Model: Bellini		Date: 30-May-00	No.: RA294014
Subject: Finisher ROM History		Prepared by: H.K.	
From: Technical Services Dept., GTS Division			
Classification:	<input type="checkbox"/> Troubleshooting	<input checked="" type="checkbox"/> Part information	<input type="checkbox"/> Action required
	<input type="checkbox"/> Mechanical	<input type="checkbox"/> Electrical	<input type="checkbox"/> Service manual revision
	<input type="checkbox"/> Paper path	<input type="checkbox"/> Transmit/receive	<input type="checkbox"/> Retrofit information
	<input type="checkbox"/> Other (      )

Model: Bellini		Date: 26-Jun-00	No.: RA294021
Subject: Finisher - Punch Waste Full Condition		Prepared by: H.K.	
From: Technical Services Dept., GTS Division			
Classification:	<input type="checkbox"/> Troubleshooting	<input type="checkbox"/> Part information	<input type="checkbox"/> Action required
	<input type="checkbox"/> Mechanical	<input type="checkbox"/> Electrical	<input checked="" type="checkbox"/> Service manual revision
	<input type="checkbox"/> Paper path	<input type="checkbox"/> Transmit/receive	<input type="checkbox"/> Retrofit information
	<input type="checkbox"/> Other ( )

Model: Bellini	Date:

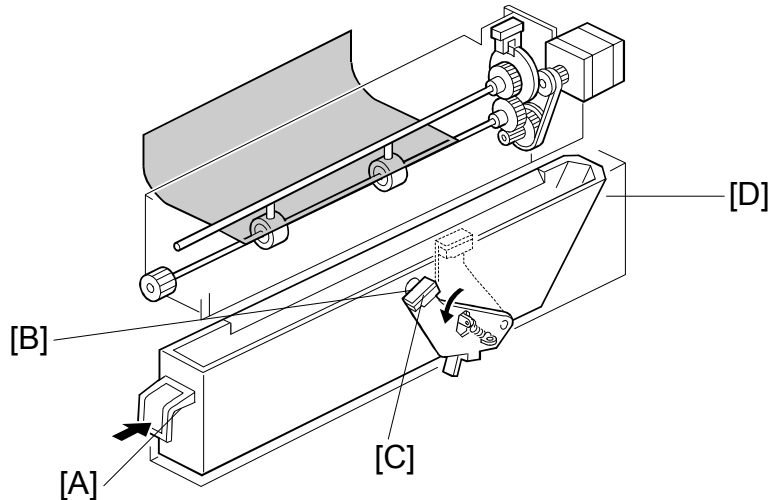
When the paper stack is removed when the tray is full, the stack height sensor feeler drops. Then, 1.5 seconds later, the finisher raises the tray and sends the "wait" signal to the copier. The copier then immediately stops the paper flow exiting to the finisher. When the tray is lifted to the top position, the finisher sends the "wait clear" signal to the copier. Then, the copier restarts exiting the paper to the finisher.

If the copier does not receive the "wait" signal, it restarts exiting the paper immediately.

Software change: The finisher sends the stop signal to the mainframe at the same time it detects that the tray is in the bottom position.

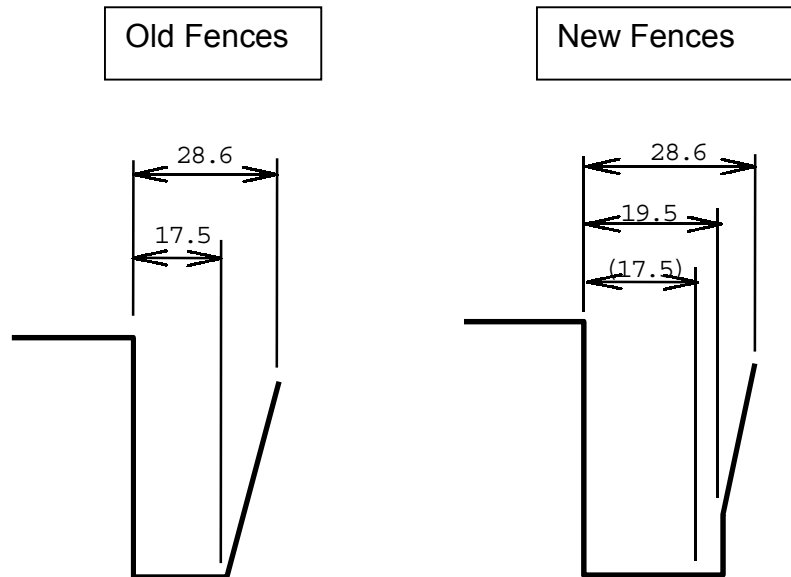
To improve the stacking ability of the jogger unit, the production machines have been modified as follows: The modification has been applied to the April production. Regarding the cut-in serial numbers, please refer to finisher MB No.003.

The widths of the positioning fences (front, middle and rear) have been increased as shown below.

Note 1: When replacing either of the old fences in the field, install all three new parts as a set.

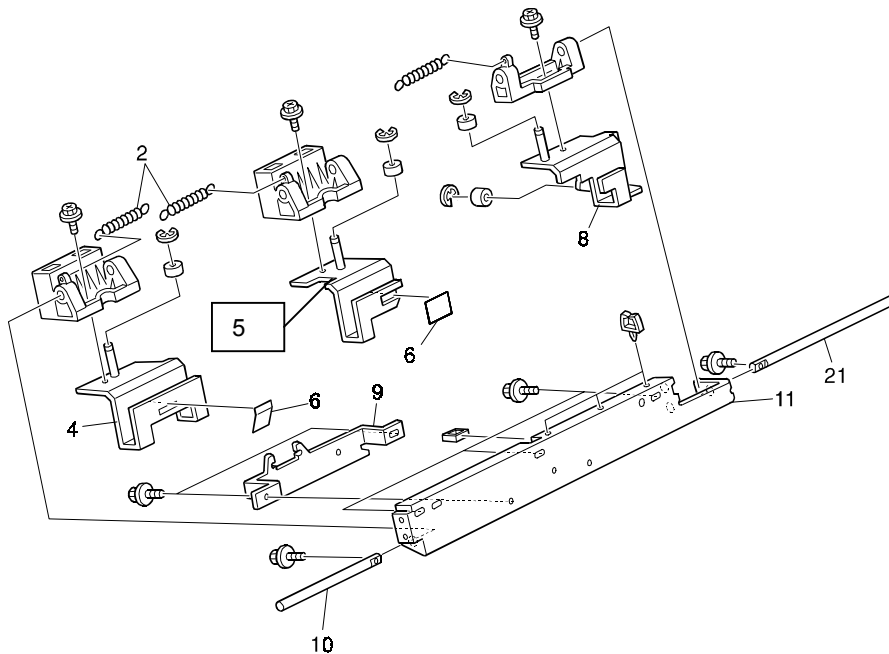
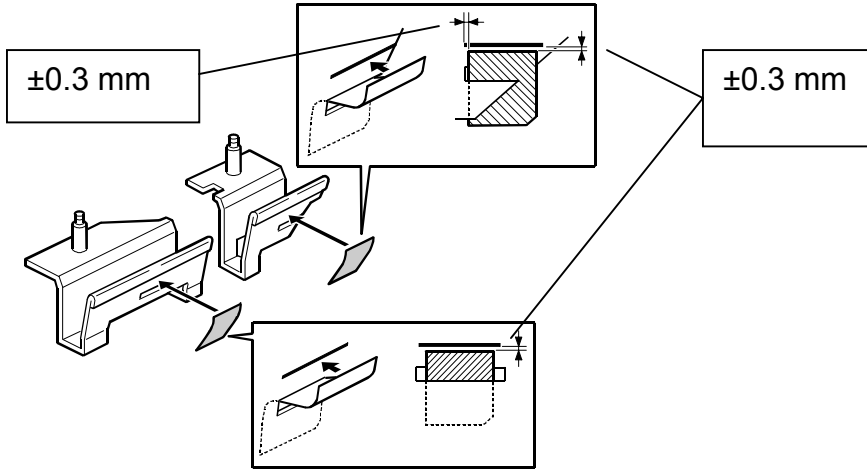
Note: In addition to installing the new three fences, it is necessary to attach two Mylar Guides (B3024517, Index 6) to the Front and Middle Positioning Fences.

1. Remove the two springs (index 2) hooked on the Slide Holder Shaft Bracket (B3024742: Index 9).
2. Remove the securing screws for the front and rear shafts (B3024541: Front Shaft - Slide Holder, Index 10 & B3014542: Rear Shaft - Slide Holder, Index 21).
3. Slide out the front and rear shafts from the Staple Unit Lower Stay (B3024741: Index 11).
4. Remove the old positioning fences (Index 4, 5, and 8).
5. Attach the two Mylar Guides (B3024517: Index 6) to the Front and Middle Positioning Fences as shown in the illustration on the next page.
6. Install the new positioning fences (front, middle, and rear).
7. Return all removed parts.

Note: Make sure that the two springs are put back correctly.

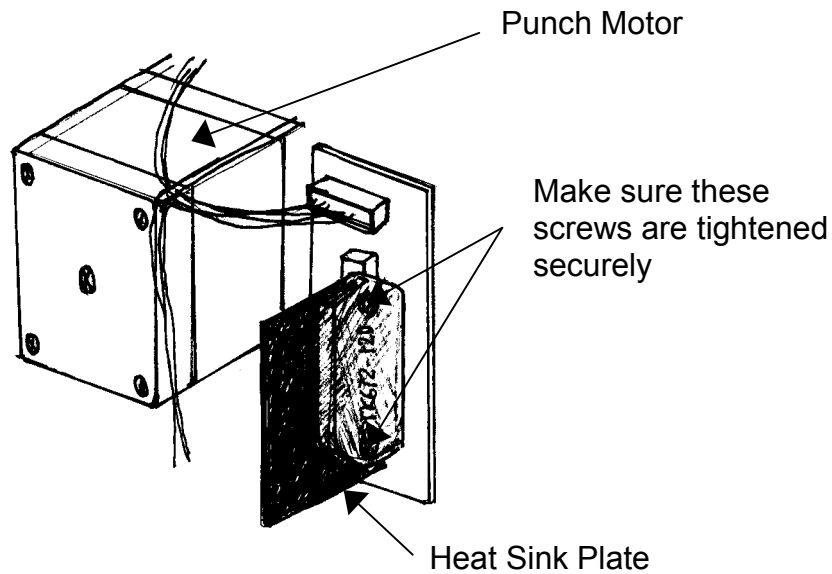
- 2 From September 2000 production of the punch units, the heat resistor securing screws have been locked in place with an adhesive.

P/N change:

Old Punch Drive Board P/N: A812-5120

New Punch Drive Board (Heat resistor screw lock) P/N: A812-5150

3-1 Please check the two heat resistor screws when visiting the machine site and tighten them if they are loose.
